## PRODUCT/PROCESS CHANGE NOTICE (PCN)

<b>PCN #:</b> TB-0609-03 <b>DATE:</b> 06-Oct-2006 <b>Product Affected:</b> All square PQFP and TQFP, MLP Dual, QFP-N, VFQFP-N packages shipped in Tape and Reel <b>Date Effective:</b> 06-Nov-2006	<b>MEANS OF DISTINGUISHING CHANGED DEVICES:</b> <input type="checkbox"/> Product Mark <input type="checkbox"/> Back Mark <input type="checkbox"/> Date Code <input checked="" type="checkbox"/> Other                      Starting 06-Nov-2006
--	---

### ATTACHMENT I - PCN #: TB-0609-03

**PCN Type:** To comply to current EIA Standard (EIA-481-C) requirement.

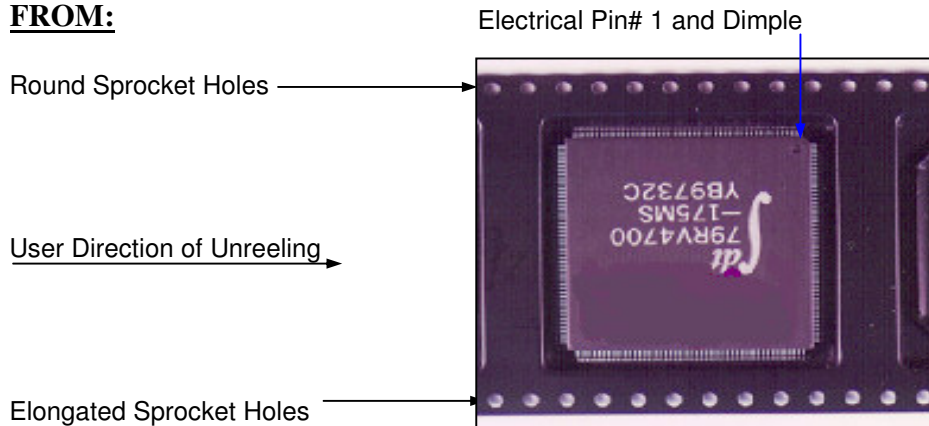
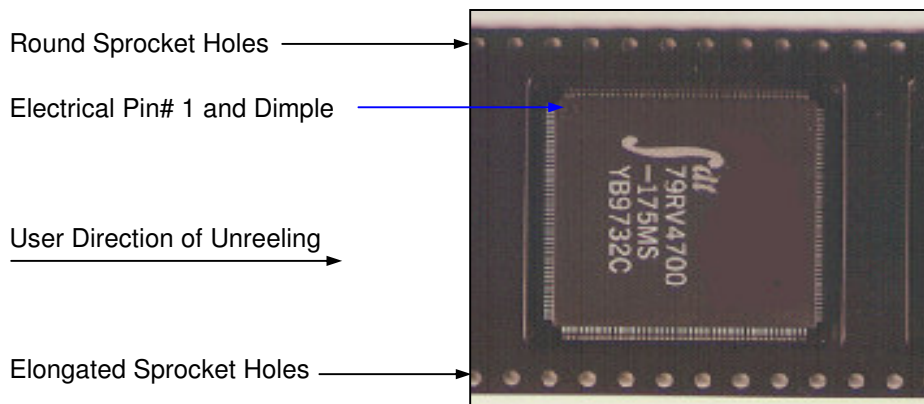
**Detail of Change:** This change will be implemented on all square PQFP and TQFP, MLP Dual, QFP-N, VFQFP-N packages.

#### **FROM:**

#### **TO:**

#### **Conversion Schedule:**

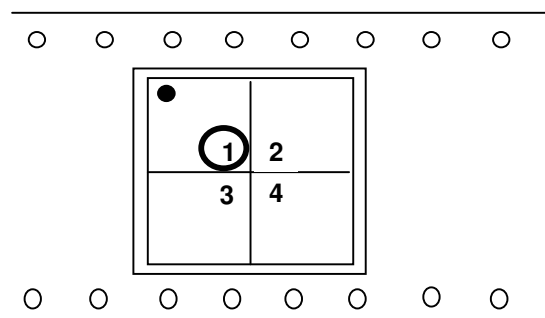
Additional label as shown below will be placed on the intermediate box (pizza box) to alert customer of this change. Label will be placed starting 06-Nov-2006 until 06-Nov-2007. However, please take note that IDT will continue to ship products in existing loading orientation until the inventory has been depleted. Customer may receive shipments in existing or new loading orientation.

● Pin One in Quadrant 1
